of a Private Plan Change to the Matamata-Piako District Plan under Schedule 1 of the RMA by Rings Scenic Tours Limited, to introduce new objectives, policies and rules, primarily through a Development Concept Plan, to enable the ongoing operation and growth of tourism activities at the Hobbiton Movie Set within an appropriate framework.

STATEMENT OF EVIDENCE OF BRIDGET MARY GILBERT

Plan No. C2

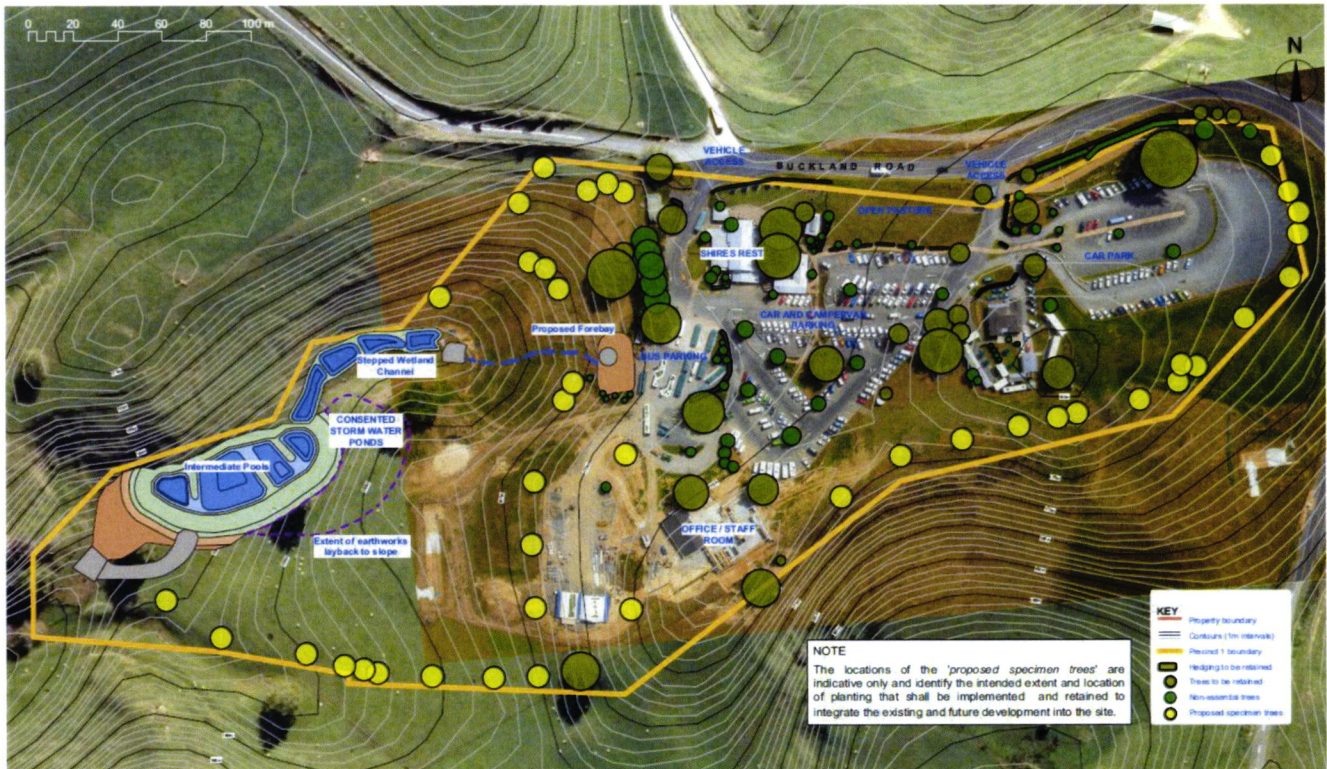
- 1.26 As at the time of completing my statement (late Friday afternoon, 5 April), I have received a copy of an updated Mitigation Plan from Mr Graham, reproduced overleaf. It is my understanding that Mr Graham supports the extent of mitigation depicted in the 5 April Mitigation Plan.
- 1.27 This plan shows an increased extent of Precinct 1 to that evaluated by Mr Graham in his evidence in chief (and the MGLA Report).

1.28 I am advised that the extent of the precinct has been expanded to include the approved stormwater treatment areas to the western side. However, under the 10% building coverage rule, the increased 'curtilage' has the effect of increasing the (permitted) building coverage by approximately 2,000m² and encompasses a new 'greenfield' area located between the approved stormwater ponds and the carpark immediately west of the Office /Staff Room (currently under construction).

1.29 I consider that for this change to be acceptable from a landscape perspective, the following amendments will need to be made to the Precinct 1 Mitigation Plan and/or plan change provisions:

- (a) The incorporation of specimen tree and hedgerow planting along the Buckland Road frontage to the west of Precinct 1, to screen views from the road to the extended Precinct area. It is expected that this planting will need to be included with Precinct 1.

- (b) The incorporation in the plan provisions of a requirement for a minimum 10m width riparian planting margin around the Precinct 1 stormwater management devices, with the riparian planting comprising locally appropriate eco sourced native species at a density of 5,100 stems/ha (1.4m centres).¹ Such an outcome is consistent with land development best practice.

1.30 I also support the approach recommended by Mr Rademeyer that the stormwater management ponds are provided for within the Rural Buffer which would leave the extent of Precinct 1 as depicted in the notified version of the plan change.
